8. Paul Taylor Subdivision; KPB File 2024-080

**ITEM #8 - PRELIMINARY PLAT
PAUL TAYLOR SUBDIVISION**

KPB File No.	2024-080
Plat Committee Meeting:	August 12, 2024
Applicant / Owner:	Paul Taylor / Anchor Point, Alaska
Surveyor:	Katherine Kirsis / Seabright Survey + Design
General Location:	Diamond Ridge area / Kachemak Bay APC

PAUL TAYLOR SUBDIVISION
A SUBDIVISION OF THE S1/2 S1/2
SEC. 33, T. 6 S., R. 13 W., SEWARD MERIDIAN, KENAI
PENINSULA BOROUGH, THIRD JUDICIAL DISTRICT, ALASKA
CONTAINING 159.810 ACRES

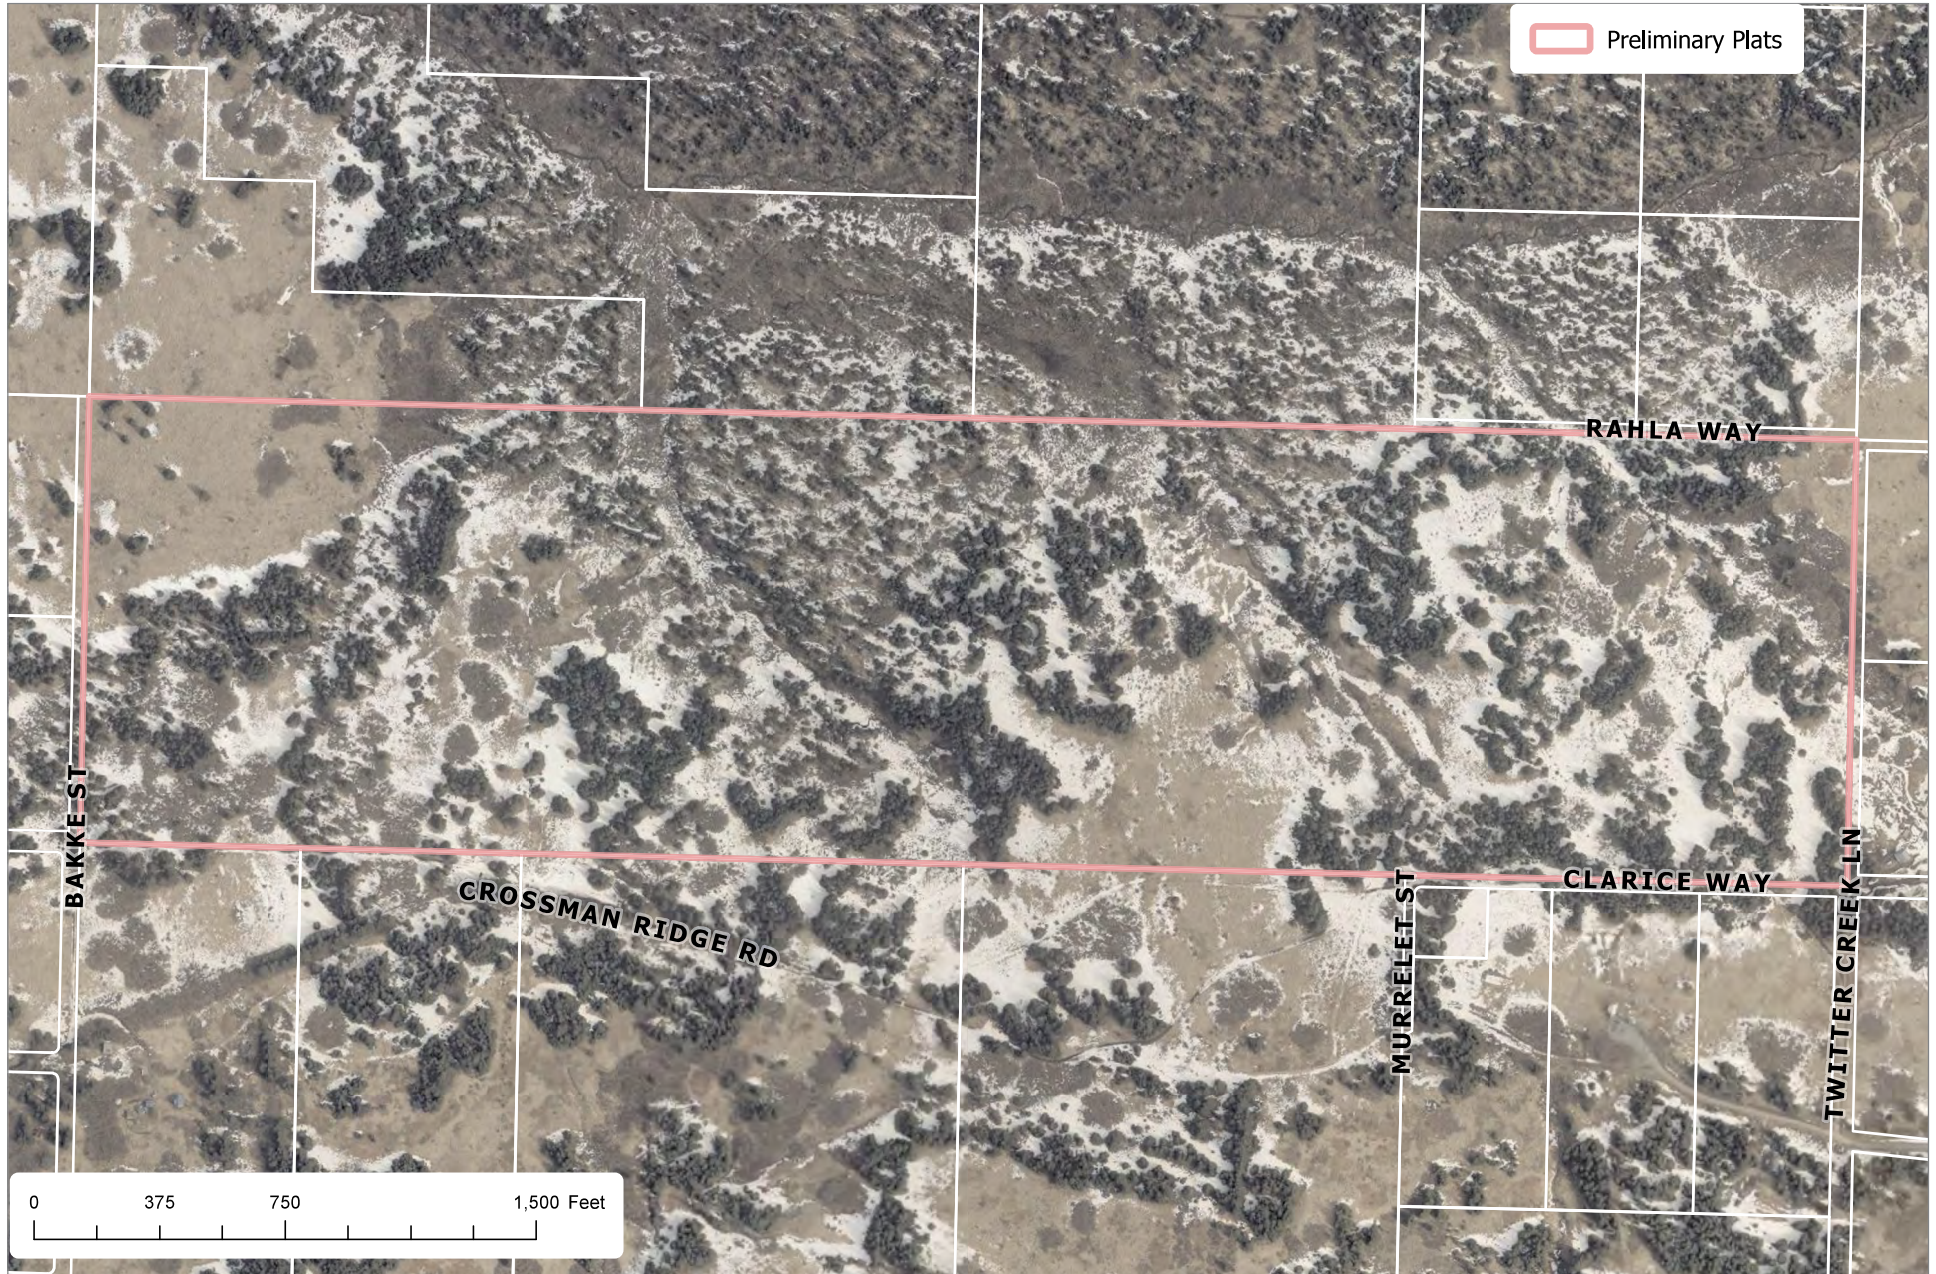
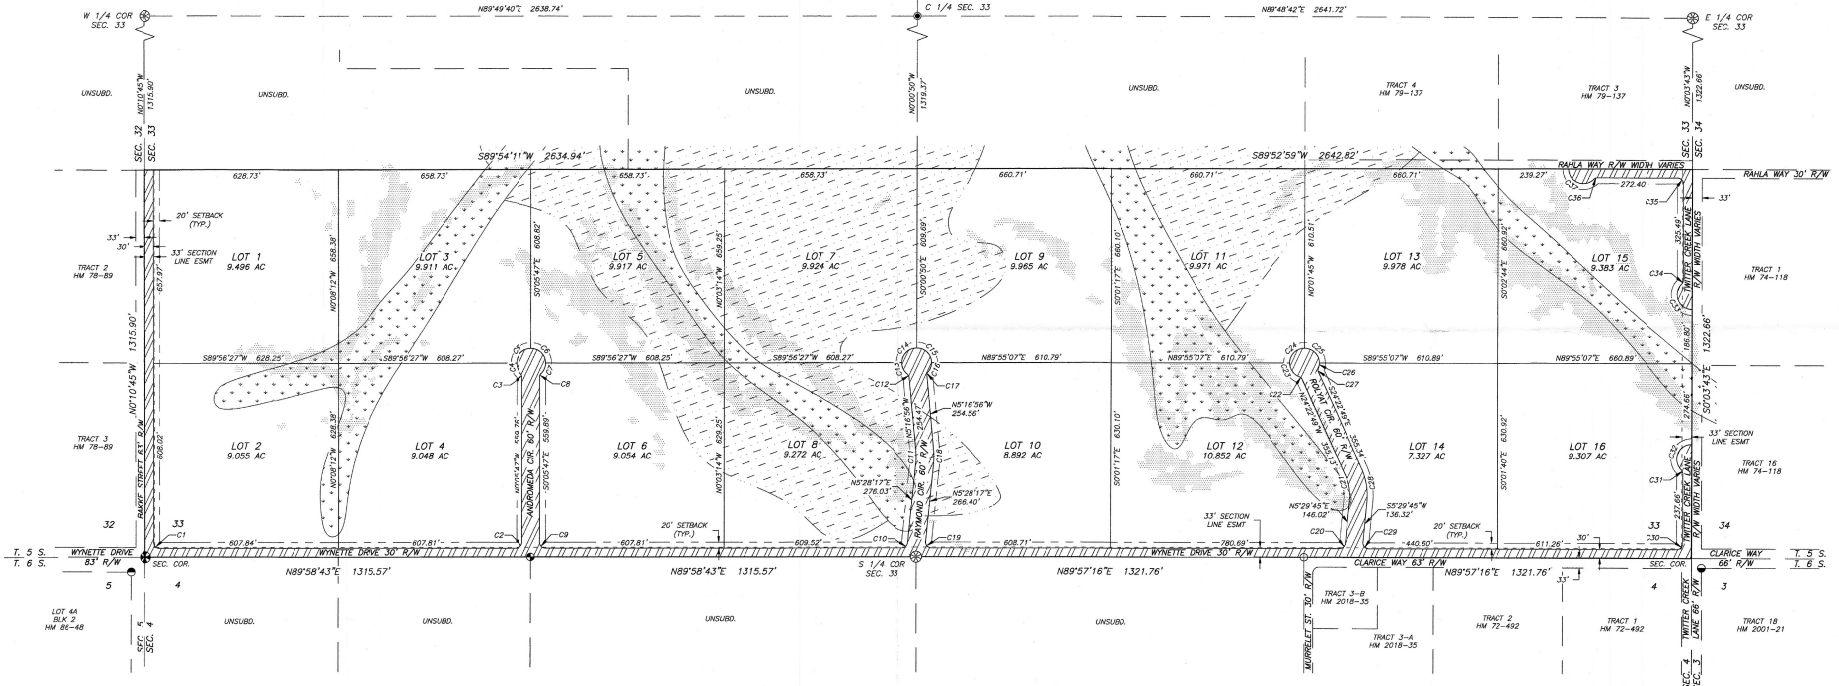
The plat is affected by a 33' section line easement as shown on the plat located on the east, south and west sides. Another 33' section line esmt identifier could be added on the south line, more to the west side for easier identification.

Surveyor should contact the Addressing Administrator about Twitter Creek Lane in the northeast corner. This portion of road may need a new name. Wynette Drive labeled on the east of plat should be checked with Addressing Administrator for correctness.

Several steep areas having slopes over 20% are shown on the plat with shading. These areas shown should remain on the final plat submittal. There are four of these steep areas shown on the plat that have created drainage runs from the south headed north towards Twitter Creek.

The plat has shown on it several areas of riverine and discharge slope wetlands on it. These areas coincide with the drainage runs going towards Twitter Creek on the plat. **Staff recommendation:** place a note on the final plat indicating any person developing the property is responsible for obtaining all required local, state, and federal permits, including a U.S. Army Corps of Engineers wetland determination if applicable.

This plat is proposing a utility easement along the front 10' adjacent to all right-of-ways. This easement is listed in plat note 1 and not shown on the plat.

- C. The location, width, and name of existing or platted streets and public ways, railroad rights-of-way, and other important features such as section lines or political subdivisions or municipal corporation boundaries abutting the subdivision;
Staff recommendation:
Existing streets should list the current width, without the new dedications included from this plat.
- D. A vicinity map, drawn to scale showing location of proposed subdivision, north arrow if different from plat orientation, township and range, section lines, roads, political boundaries, and prominent natural and manmade features, such as shorelines or streams;
Staff recommendation:
Add adjacent roads to the vicinity map some to get to site
Bear Creek is mislabeled, KPB GIS labels is as Palmer Cree

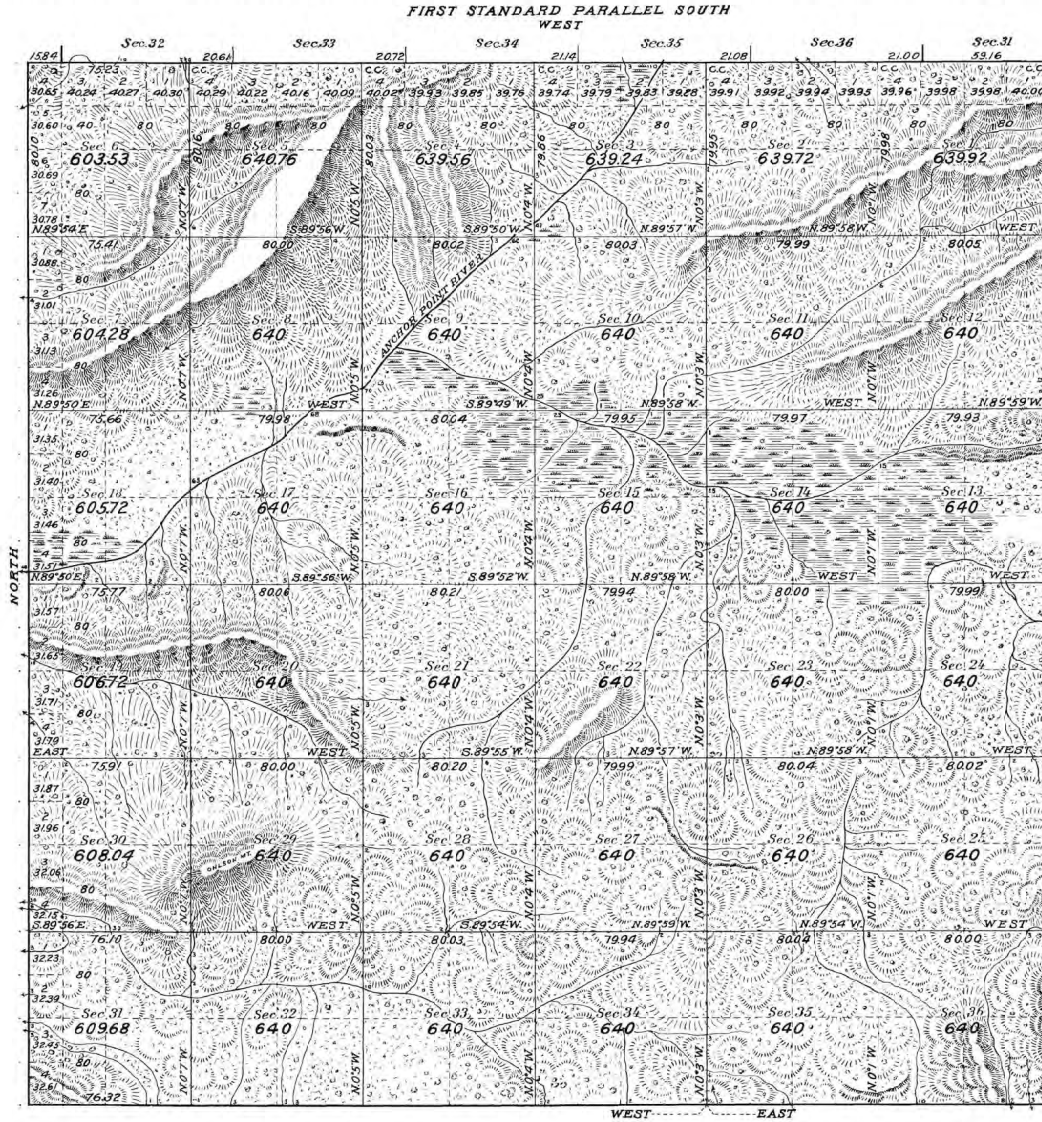
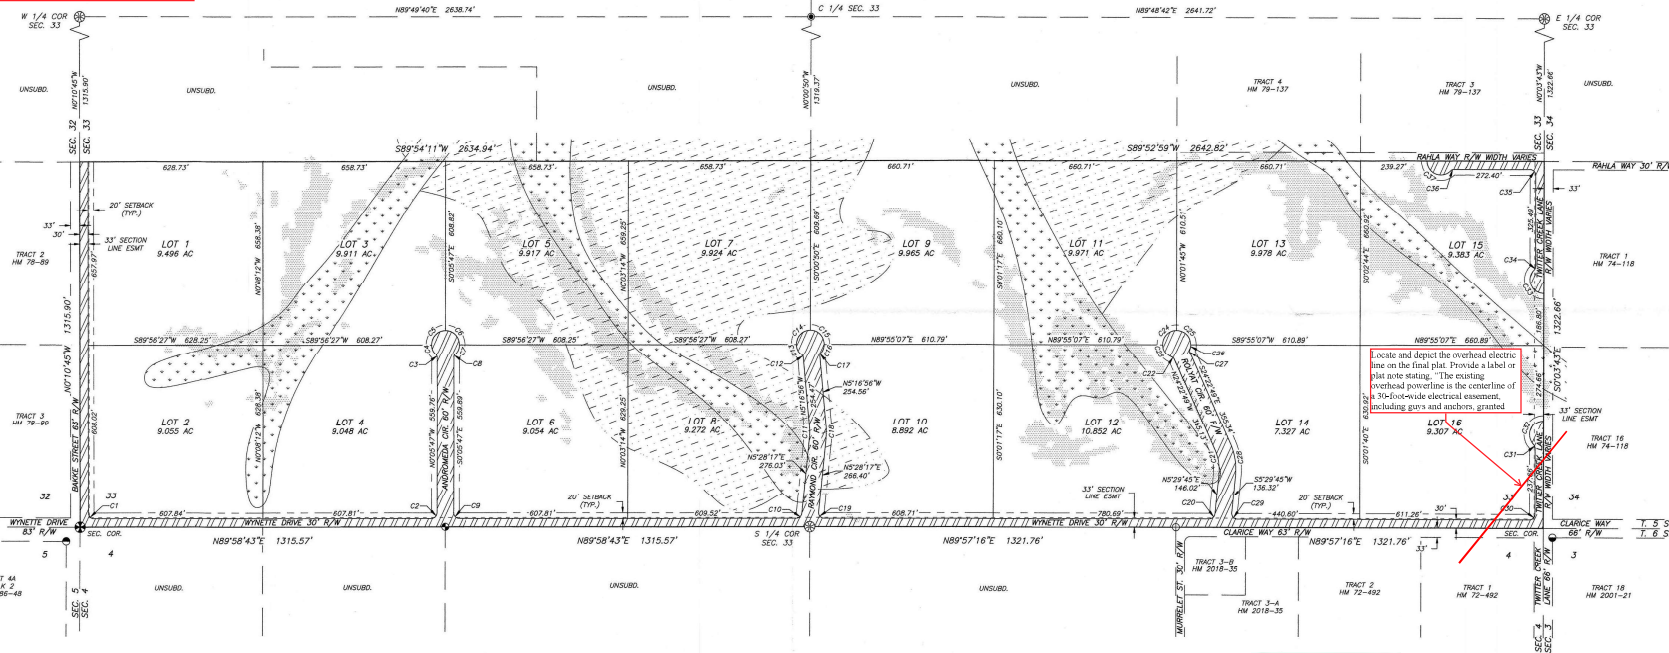
Provide a 15 foot wide electric easement adjoining all indicated right-of-ways.

Locate and depict the overhead electric line on the final plat. Provide a label of plat note stating, "The existing overhead powerline is the centerline of a 30-foot wide electrical easement including gas and anchors, granted."
